SERVICE BULLETIN

PURPOSE : INFORMATION	ISSUE NO. : MSB-10E00-006	DATE : 2010-06-05
SUBJECT : INFORMATION ON 2011 LANCER AND LACER SPORTBACK FOR BODY REPAIR MANUAL		<MODEL> (EUR/RUSSIA) LANCER (CY0A) LANCER SPORTBACK (CX0A) <M/Y> 11
GROUP : GENERAL

OUTLINE OF CHANGE

The section "SILENCER APPLICATION LOCATIONS" has been established.

<1800 Petrol engine (Vehicles for Russia)>
<2000 Petrol engine (Vehicles for Russia)>

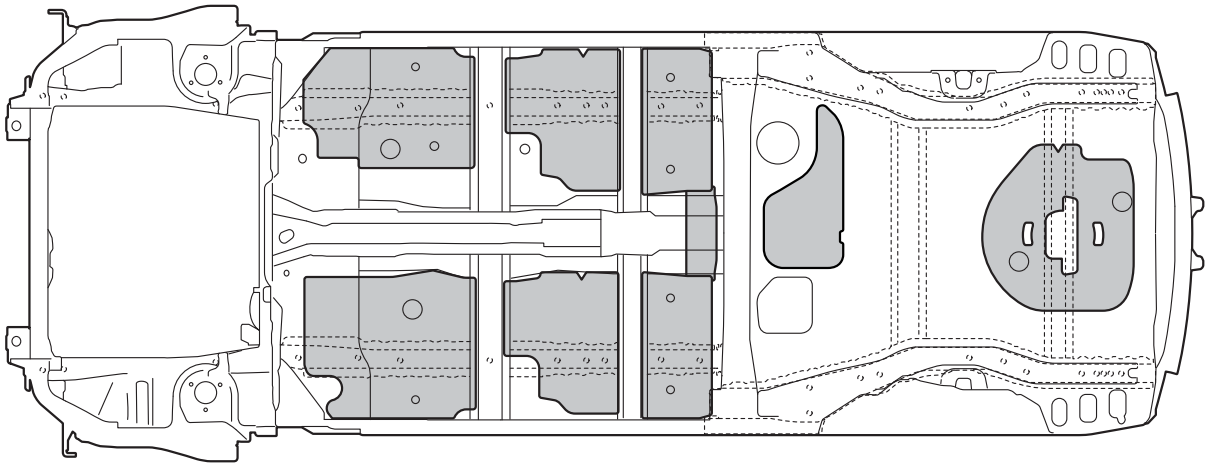
A silencer (MD-12 and melting sheet) has been affixed on the upper surface of the floor for vibration damping.

NOTE :
: 1.6 mm thick melting sheet

<Vehicles for Europe (Petrol engine) and optional item for Russia>
<RALLIART>

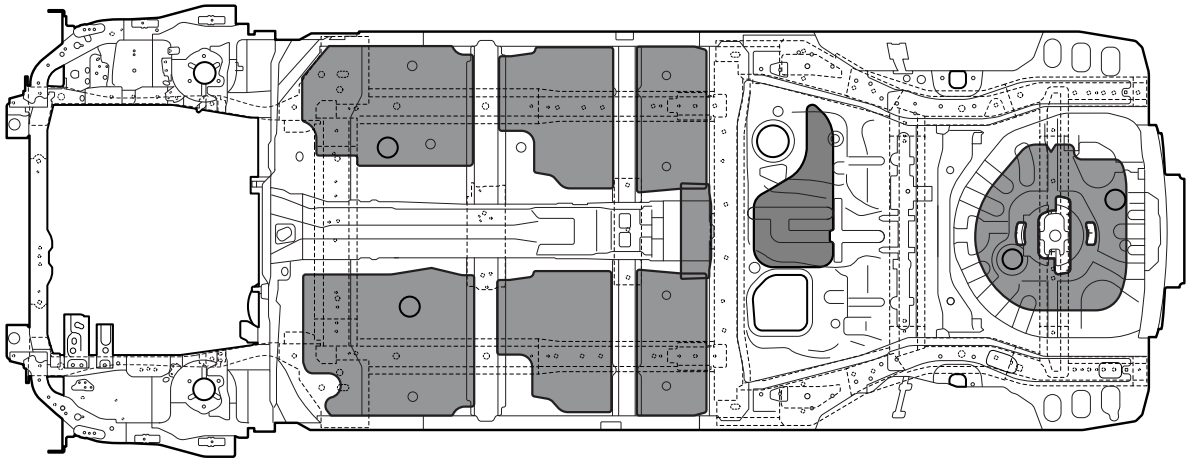
A silencer (MD-12 and melting sheet) has been affixed on the upper surface of the floor for vibration damping.

NOTE:
: 3.2 mm thick melting sheet (Place two melting sheet one on top of another.)
( ) indicates the number of 1.6 mm melting sheets that are used for repair.
